MIAMI BEACH

Staff Report & Recommendation

Historic Preservation Board

SUBJECT: HPB18-0240, **2000 Park Avenue, 2030 Park Avenue, 425 20th Street, 435 20th Street, 430 21st Street, 450 21st Street & 2035 Washington Avenue – Collins Park Hotel.**

1999 Exterior Photographs of 425 20th Street, Sun King #2

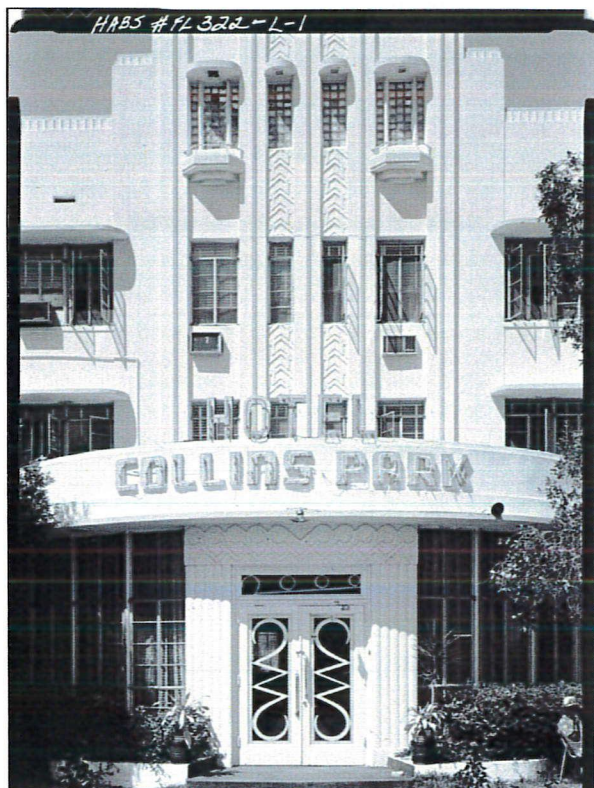
The project as approved by the Board in 2012, included the demolition of 63'-10" of rear of the 110'-0" long structure (approximately 58% of the rear of the building). As noted in the applicant's Letter of Intent, "the intricate site work and unanticipated deterioration led to the demolition of the Sun King #2."

Staff has located several pages of microfilm plans for the previously existing structure, and in conjunction with the applicant's historical documentation, staff is confident that the front 46'-2" of the building can be accurately reconstructed.

- i. The exterior front approximately 46'-0" of the Sun King #2 building shall be reconstructed consistent with available historical documentation and the plans previously approved by the Board, in a manner to be reviewed and approved by staff consistent with the Certificate of Appropriateness Criteria and/or the directions from the Board.
